EXHIBIT A

Re: Miramar Beach Resort and Bungalows Project
Citizens for Responsible Development at Miramar Beach
Subsequent EIR Notice of Preparation, Scoping Comments

B&E Engineers has reviewed the Draft Subsequent EIR (SEIR) and Addendum Report dated April 1, 2008 for the Miramar Hotel Project and has the following comments / questions and request for additional clarifications.

FIGURE I

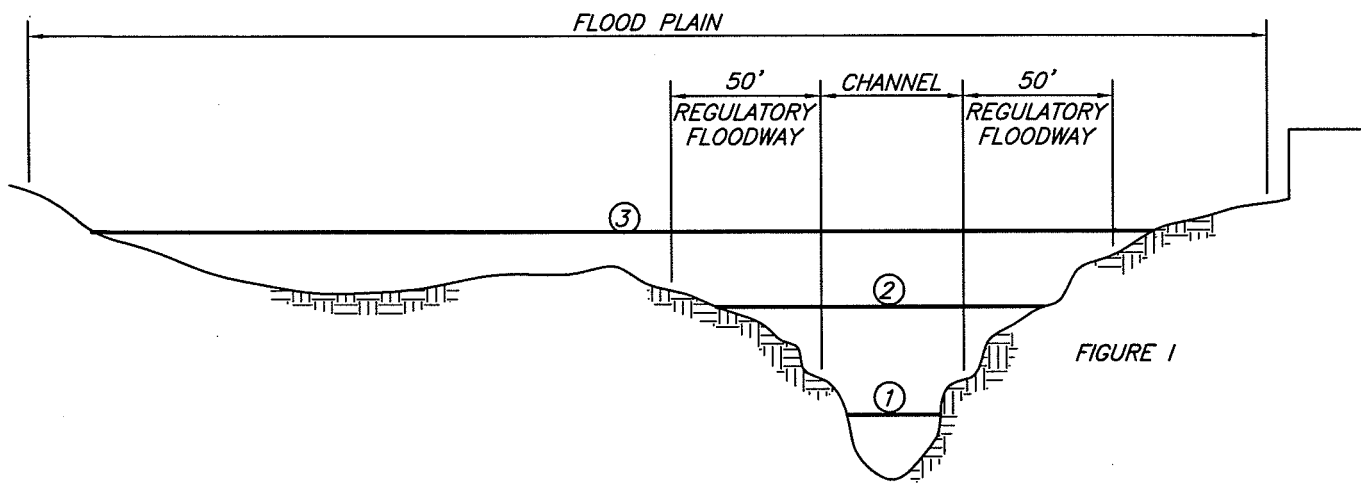
- Figure I show a typical cross section of existing ground that includes a channel, a regulatory floodway (50-foot setback from the channel) and a flood plain (water surface elevation at FEMA 100-year flow). It is generally allowed to construct within the flood plain, but not within the regulatory floodway.

- During a given storm, water surface elevation would vary depending on the flow amount. Figure I show three water surface elevations. Water surface elevation 1 is contained within the channel, water surface elevation 2 is contained within the regulatory floodway and water surface elevation 3 is contained within the flood plain.

FIGURE II

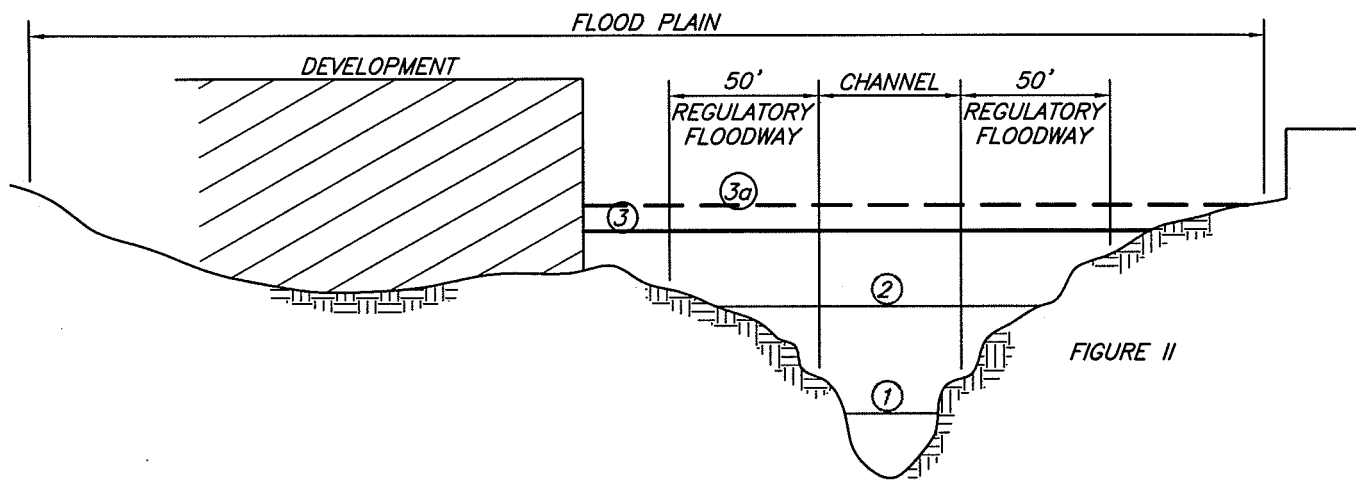
- Figure II shows a proposed development within the flood plain area. This development should not have any effects on the water surface elevations 1 and 2, but probably, depending on the size of the development, would have an effect on water surface elevation 3. This is due to the fact that the development may reduce the area of flow so the water surface elevation may rise from 3 to 3b. Depending on the specific conditions of a cross section, the water velocity may also increase or a combination of both would occur.

FIGURE III

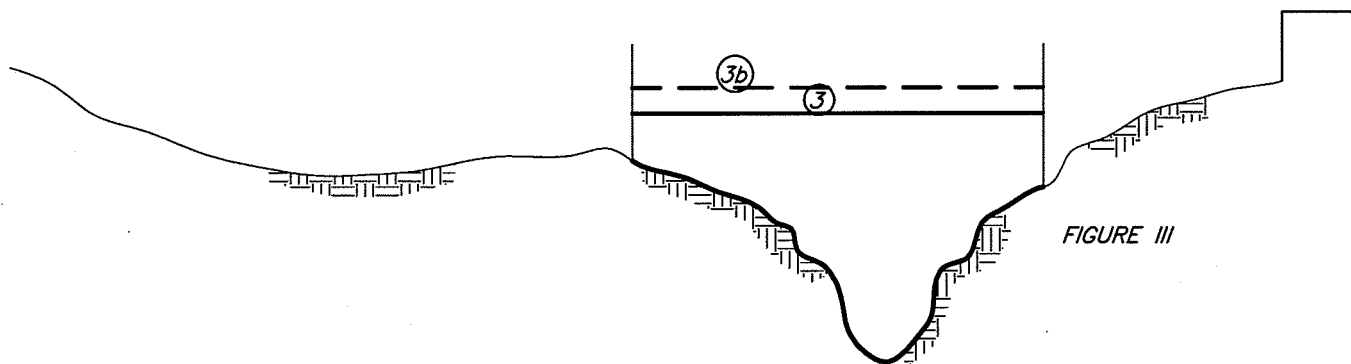
- If the cross section is not complete (left and right), the program will assume that there are vertical walls at the end points of the cross sections as shown on figure III which might provide inaccurate results.
